CITY OF WEST LAKE HILLS, TEXAS
NOTICE OF CITY COUNCIL REGULAR MEETING
Wednesday, October 28, 2020 at 7:00 PM

Doucet & Associates, Inc. (Doucet), is pleased to submit this response letter to our September 29, 2020 engineering drainage report documenting the analysis of a partial easement release located at 2 Downie Place in West Lake Hills, Texas. Our response to Comments 3-8 are as follows in blue text.

Cross Section 3 (DEVELOPED)

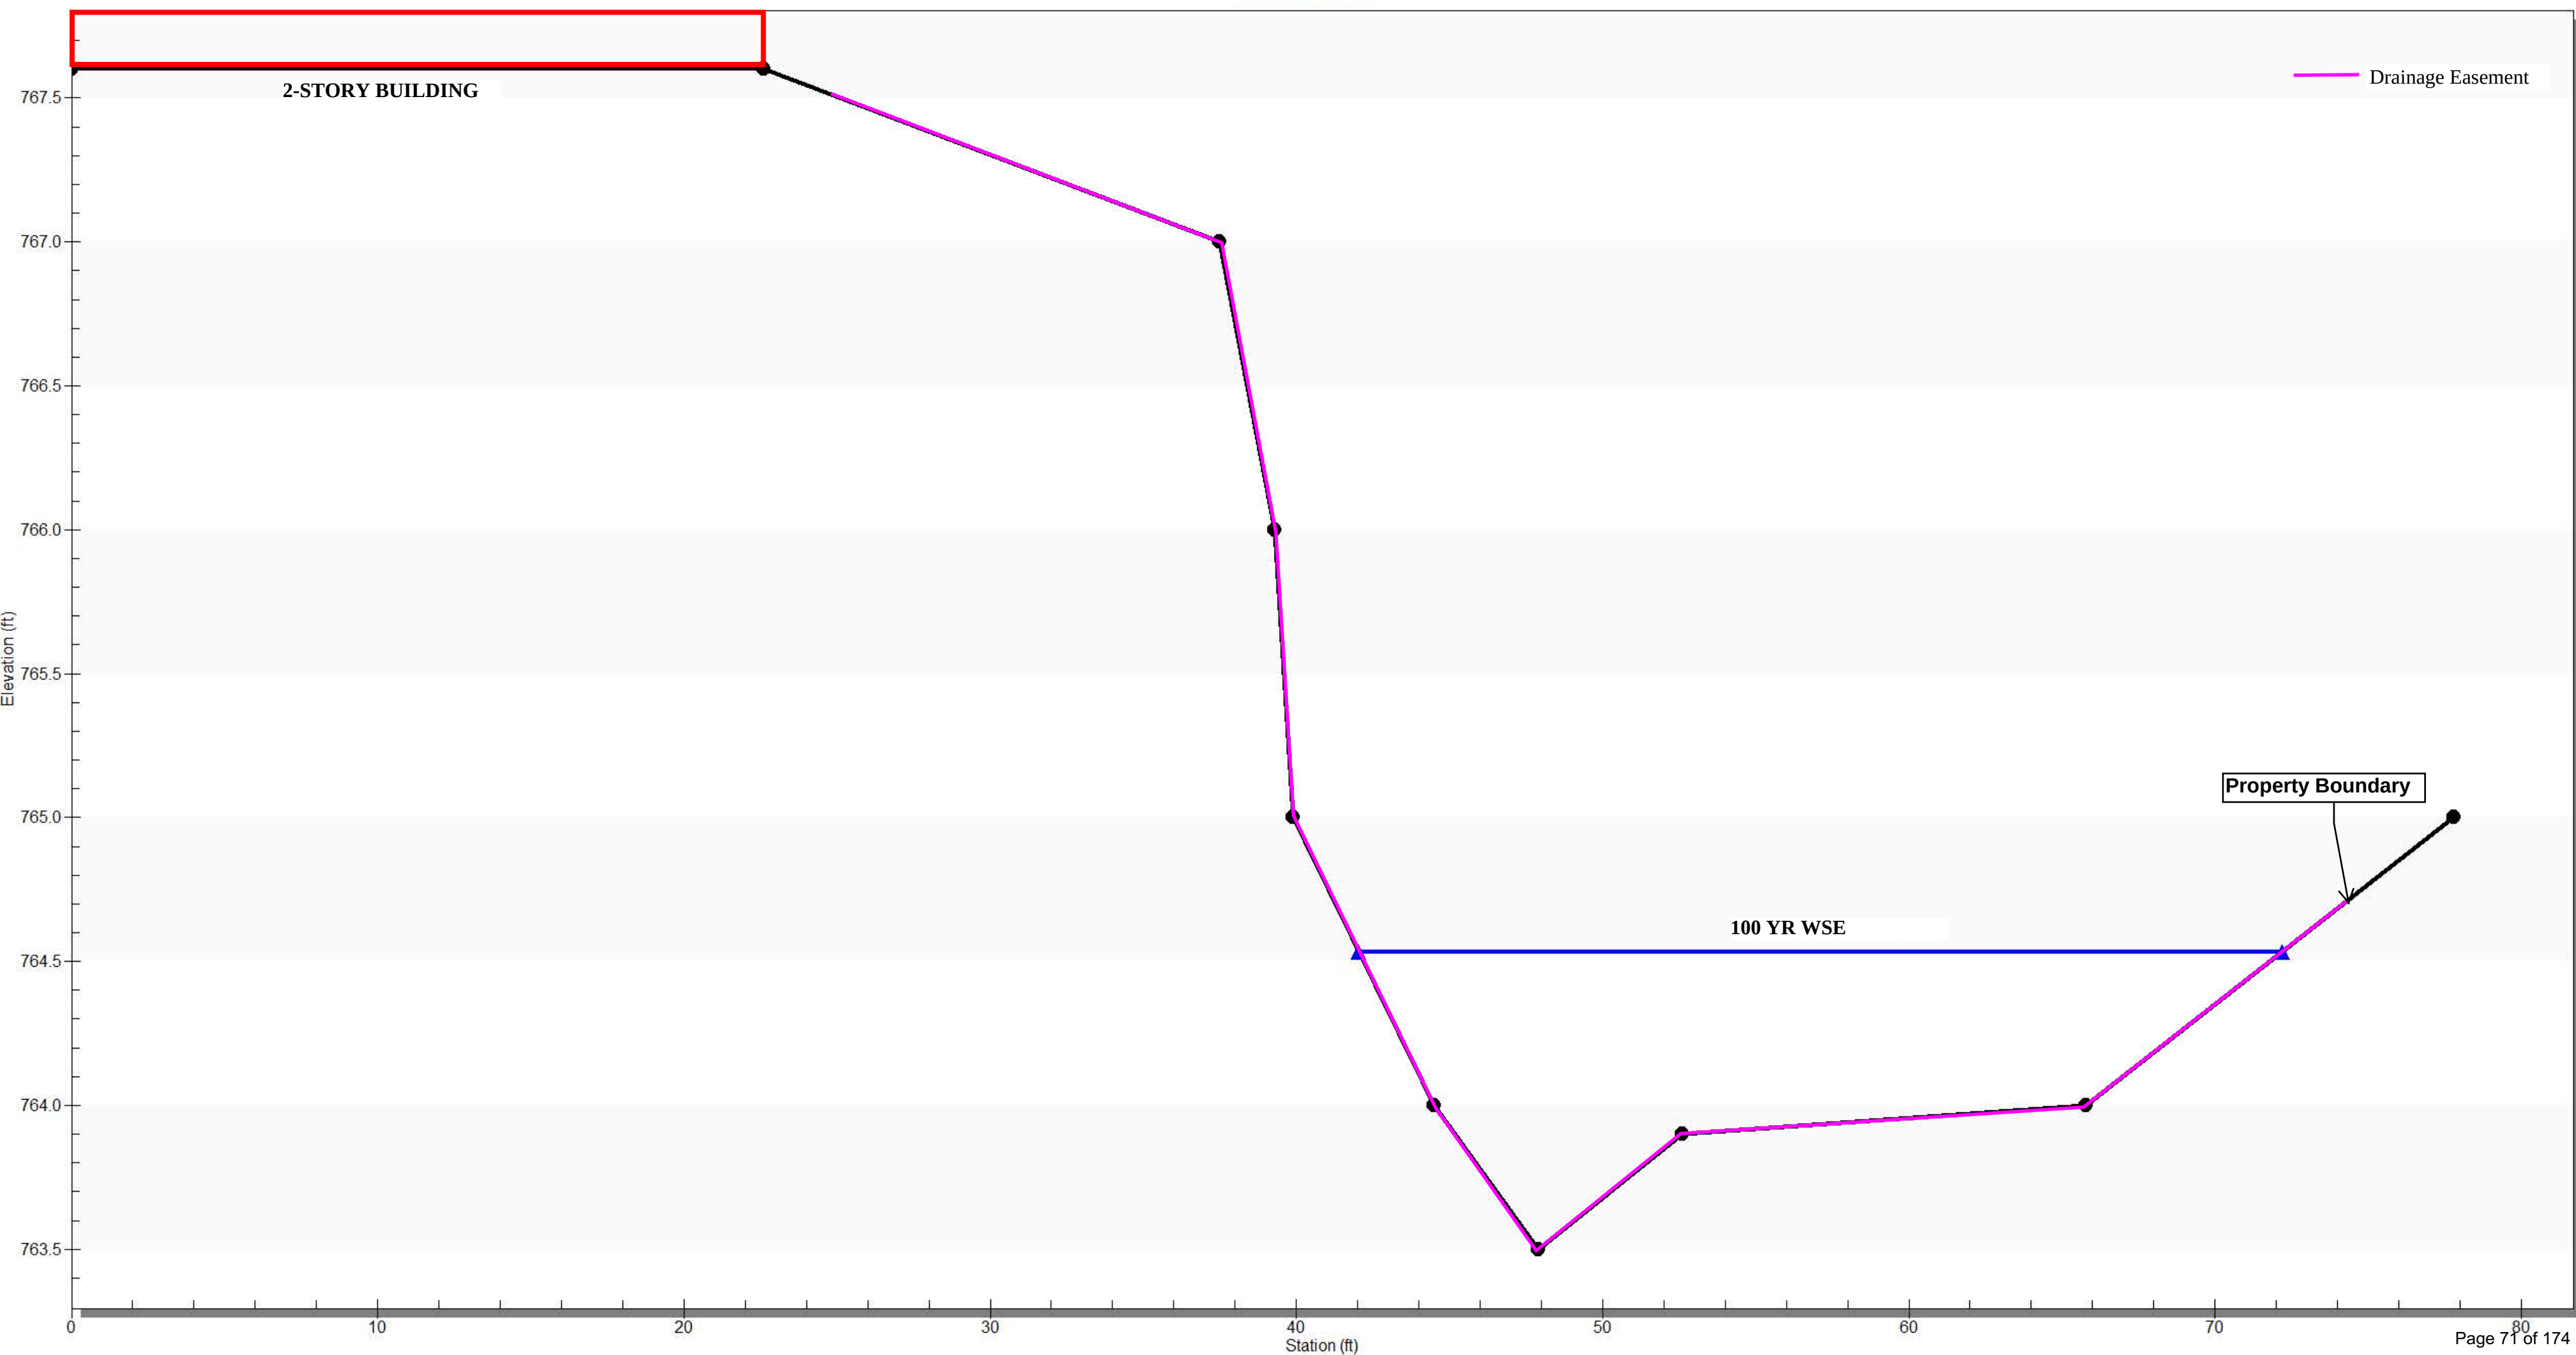
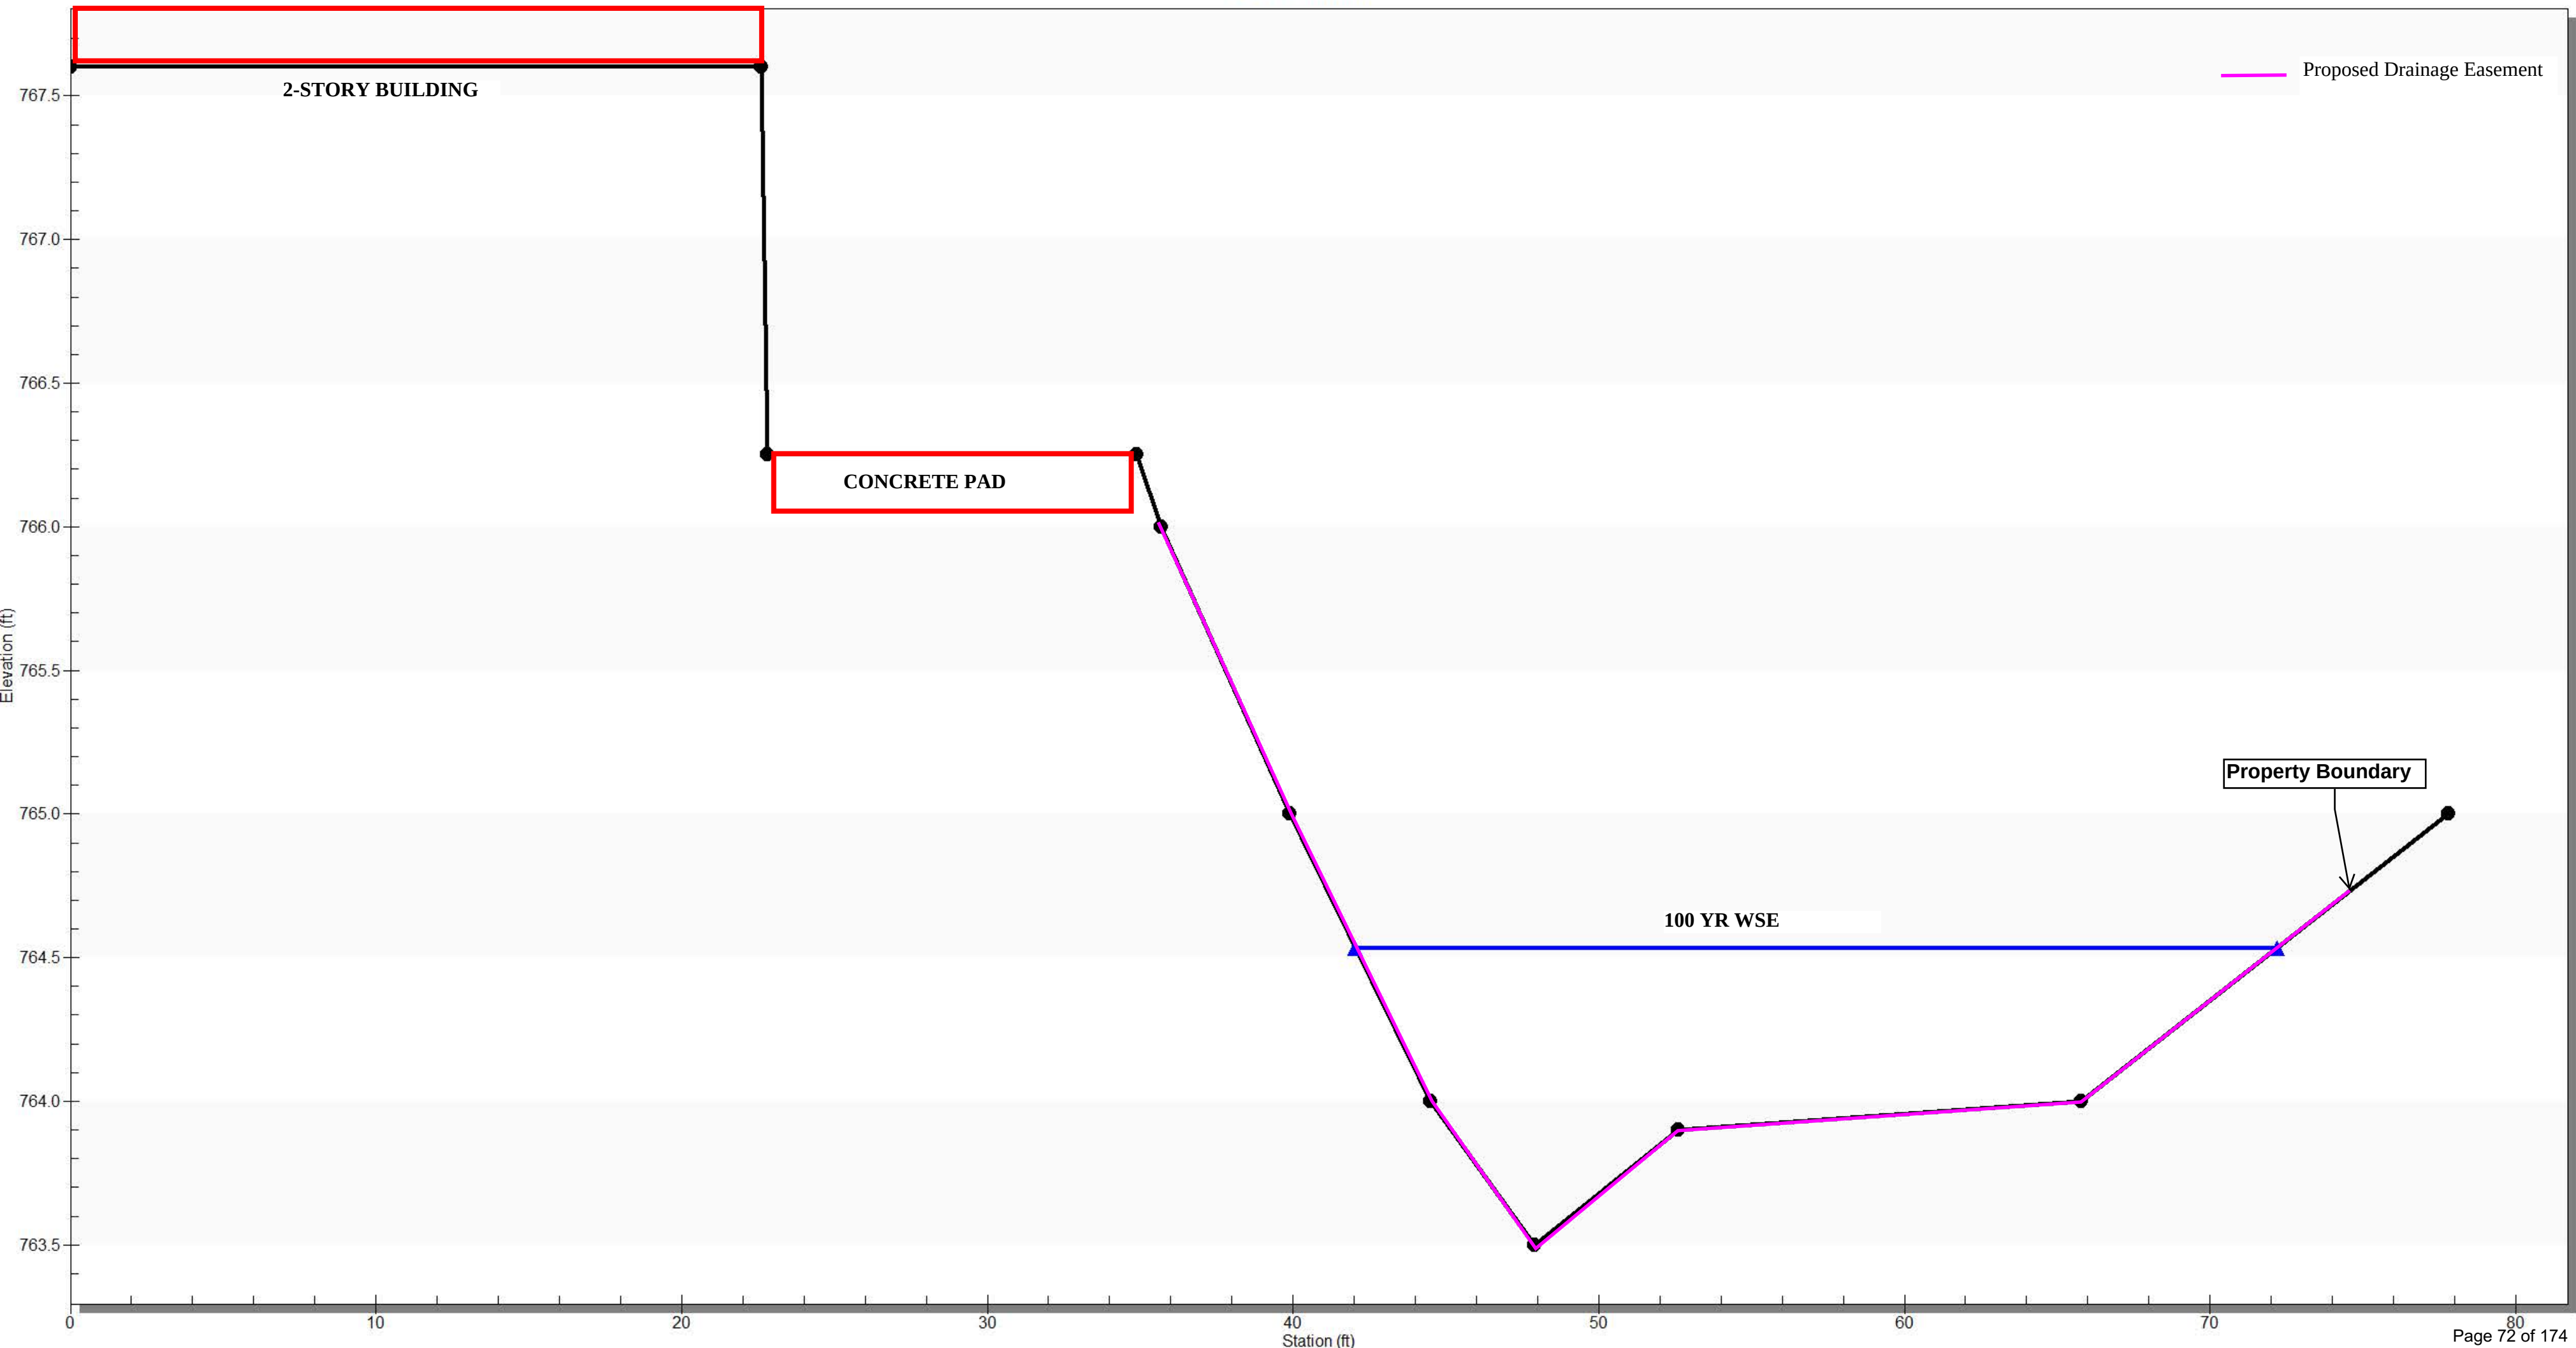
3. Please verify Easement overtopping elevations as they appear to be inconsistent with the survey provided.

3-C1) Please show property line, existing, and proposed easement line in the cross section to verify overtopping elevations.

7-C1) Please show property line, existing easement line, and proposed easement line in the cross sections.

Response: Easement lines and property boundary has been added to cross sections.

Response: Easement lines and property boundary has been added to cross sections.
